SERVICE INSTRUCTION

RUNNING MODIFICATIONS ON

ROTAX® ENGINE TYPE 912/914 (SERIES)

SI-912-020 R5

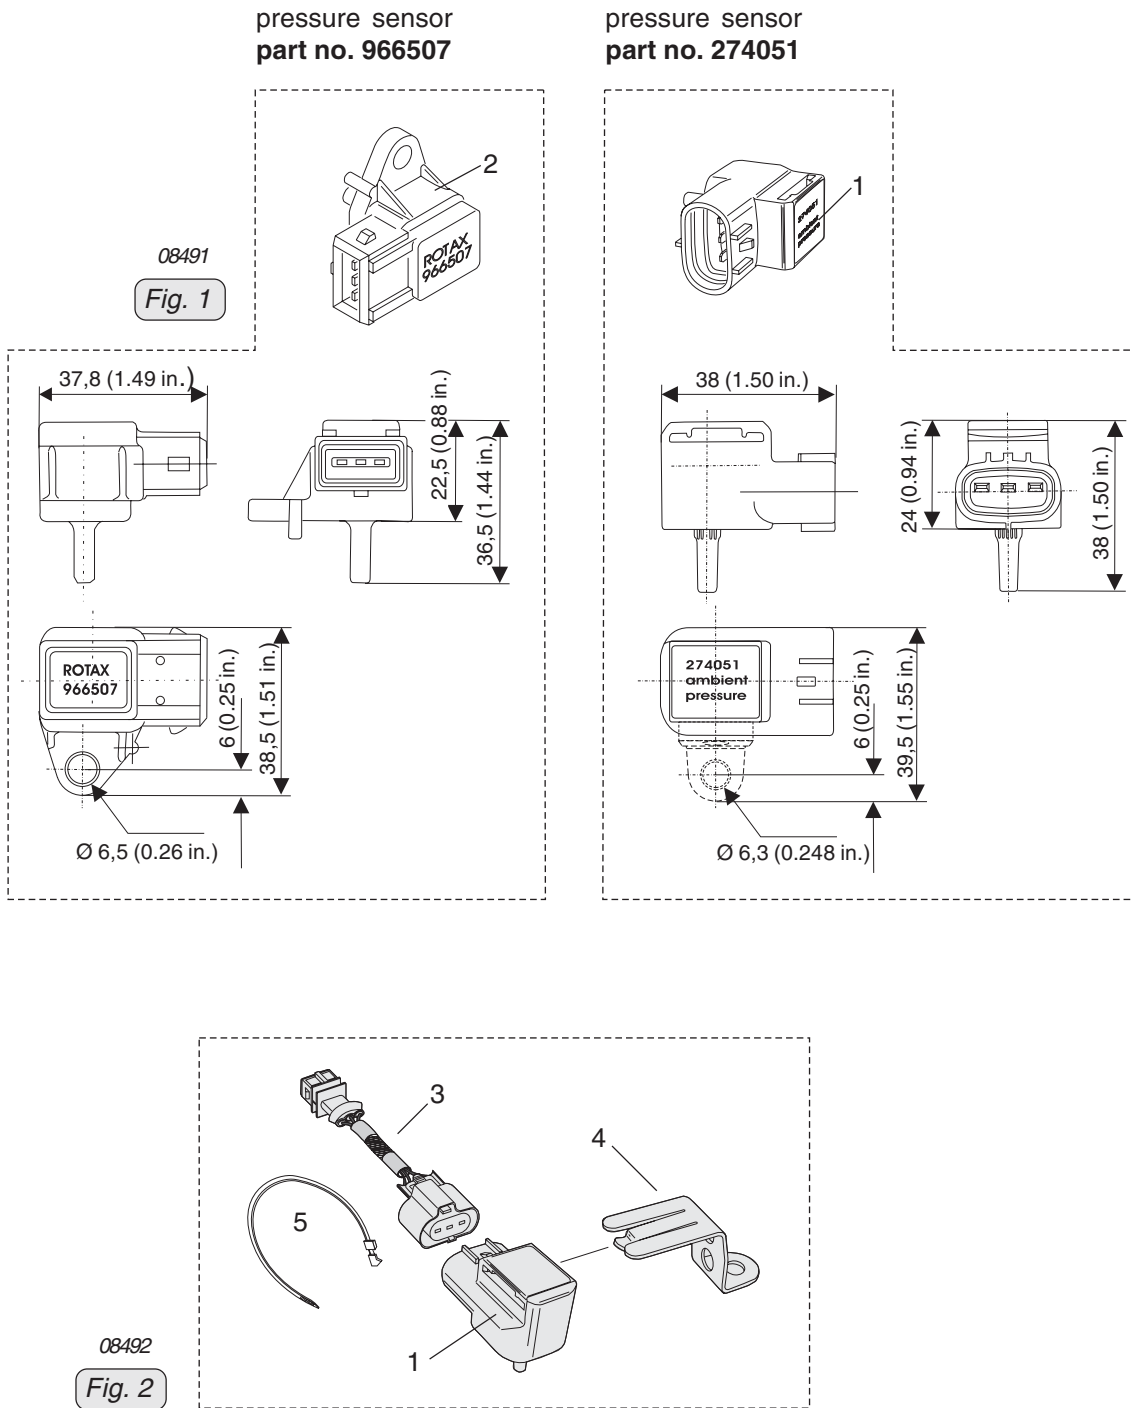
Due to the termination of production of the ambient pressure sensor (part no. 966507) a new ambient pressure sensor part no. 274051 has been introduced. The new ambient pressure sensor is of different size and also has a different connector. The connection for the wiring harness had to be changed.

1. Disconnect the pressure sensor (2) from the wiring harness.
2. Connect adapter cable (3) to wiring harness and to the new pressure sensor (1).
3. Install bracket (4) onto pressure sensor.

■ CAUTION: Route all wiring as such that there will be no sharp bends or chafing.
4. Position adapter cable and secure with cable binders (5).

new Version

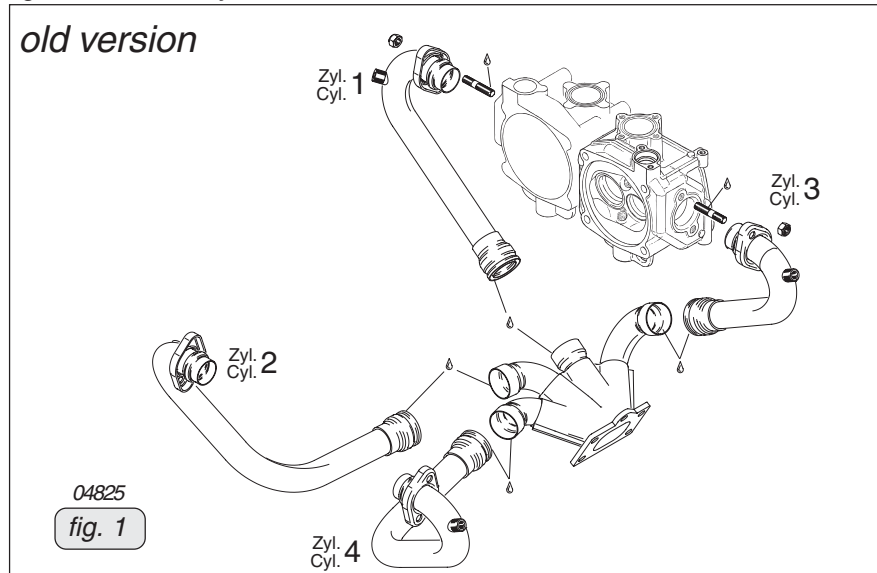
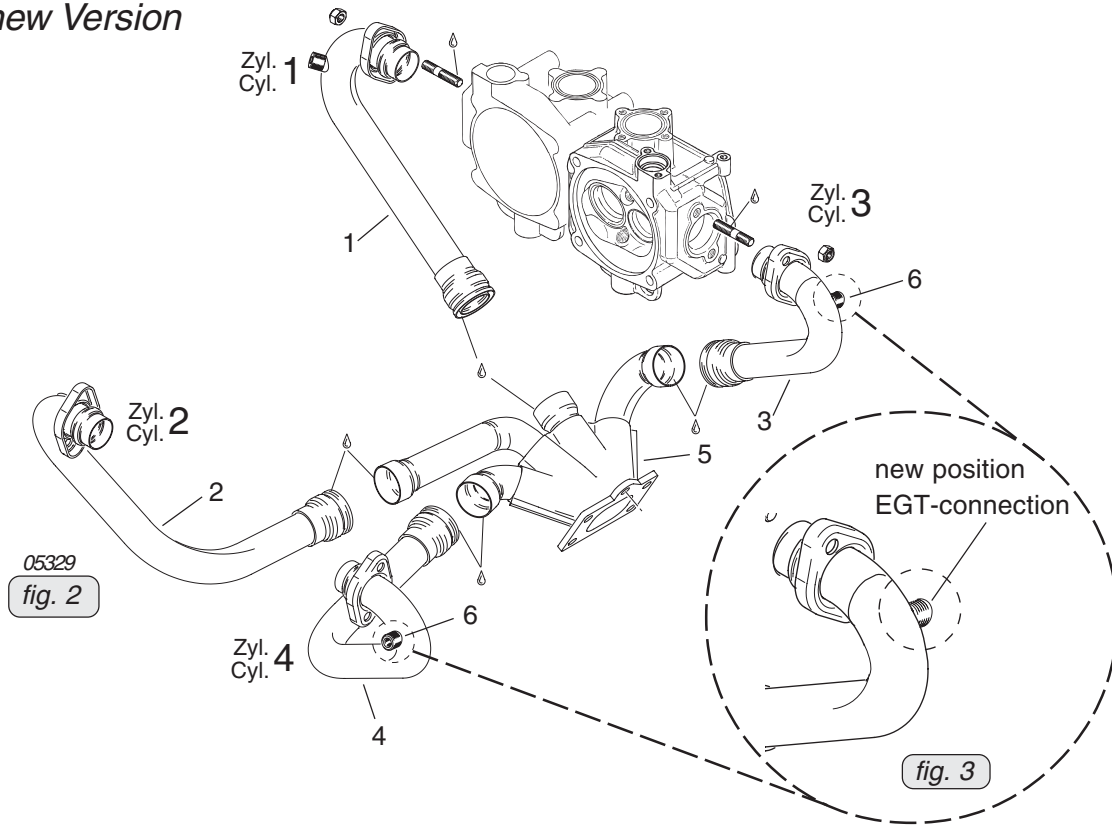
Owing to continuous further development, the exhaust bends were slightly re-worked. The couplings were optimized for their position.

- Position of the EGT connections (6) to the exhaust bends for cylinders 3 and 4 were routed such that installation of the new drip trays is possible.

fig. 2

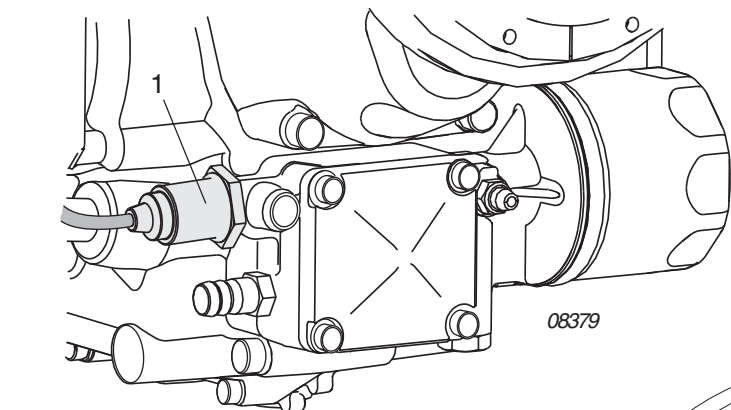
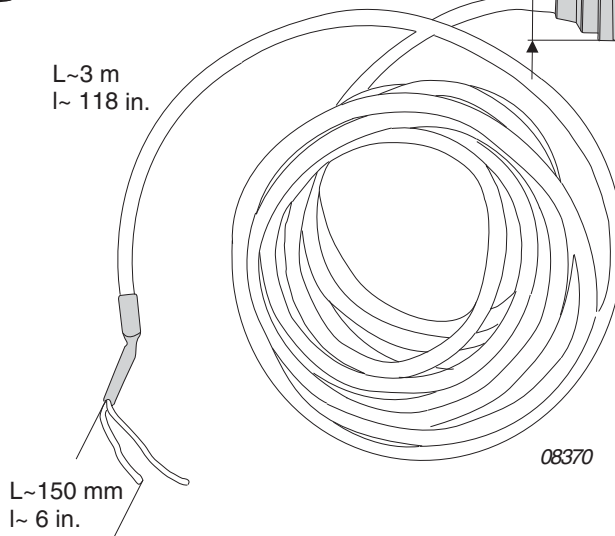
In the course of further development and standardization a new oil pressure sensor part no. 956413 has been introduced.

The sensor cable is approx. 3 m long and has 3 leads. The **Black** lead is not to be connected and has no function. The **Red** lead from the sensor has to be connected to the positive bus via a fuse or circuit breaker. The **White** lead (output signal) has to be connected directly to the instrument. See also the relevant instructions of the instrument supplier/aircraft manufacturer for correct connection and wiring.

fig. 3

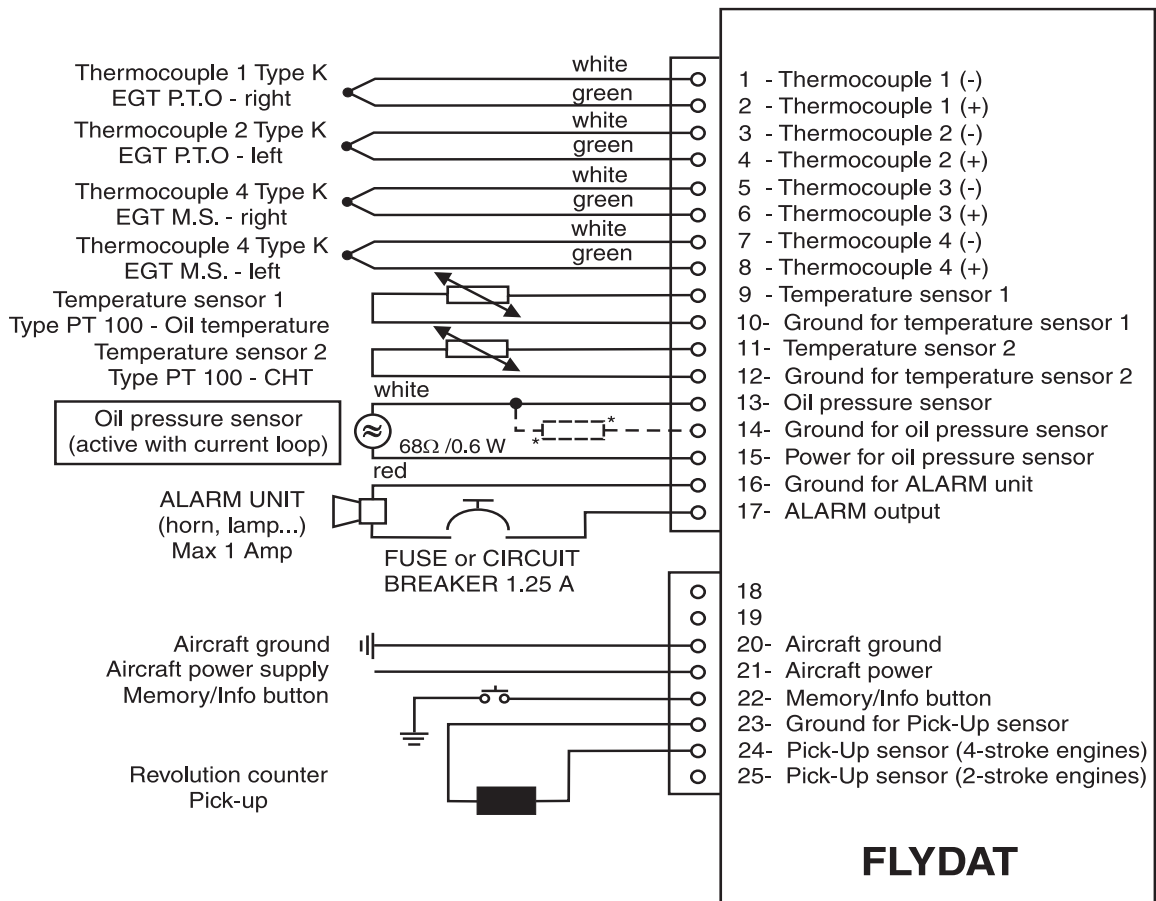
* resistor is part of the retrofit kit for Flydat part no. 886857. See also 1.3.2.

fig. 4

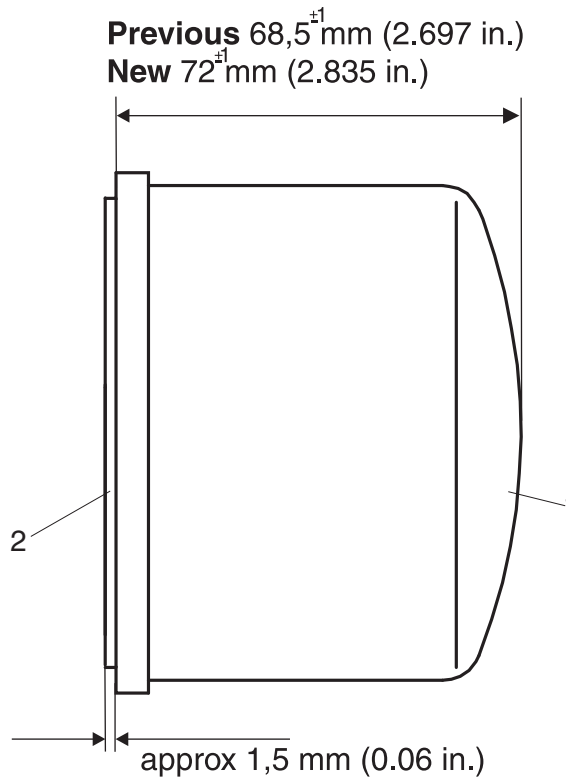
- installation height of oil filter (height increased by 3,5 mm/0,138 in.)
